Work Order ID 132779

DRAWING NO. D3303	TITLE HEAD REST	REV. B	DART AEROSPACE LTD ENGINEERING ORDER		D.E.O. NO. D3303-B-1	SHEET NO. SHEET 1 OF 1	SCALE NTS
DRAWN AJS	CHECKED <i>[Signature]</i>	MFG. APPR. <i>[Signature]</i>	APPROVED <i>[Signature]</i>		DE APPR. <i>[Signature]</i>		
DATE 08.10.15	DATE 08.10.15	DATE 08/10/16	DATE 08/10/16		DATE 08/10/16

D3303-041 HEAD REST

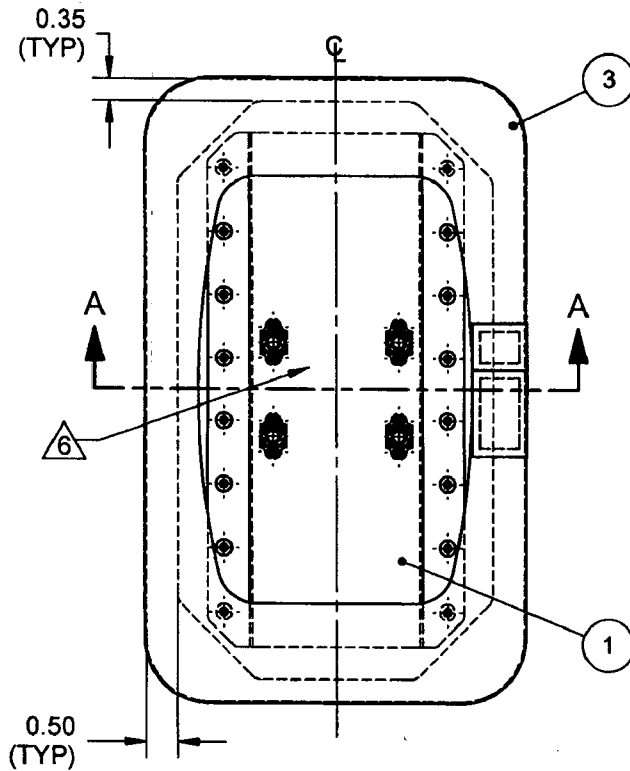
SHEET 1 ADD 1300L ADHESIVE BY 3M TO NOTE 1 AS FOLLOWS:

IS:

- 1) BOND D3305-1 FOAM TO D3303-043 BRACKET ASSEMBLY USING 3M 1300 OR 1300L ADHESIVE (0.002" TO 0.010" THICK) IN ACCORDANCE WITH MANUFACTURER'S INSTRUCTIONS

WAS:

- 1) BOND D3305-1 FOAM TO D3303-043 BRACKET ASSEMBLY USING 3M 1300 ADHESIVE (0.002" TO 0.010" THICK) IN ACCORDANCE WITH MANUFACTURER'S INSTRUCTIONS
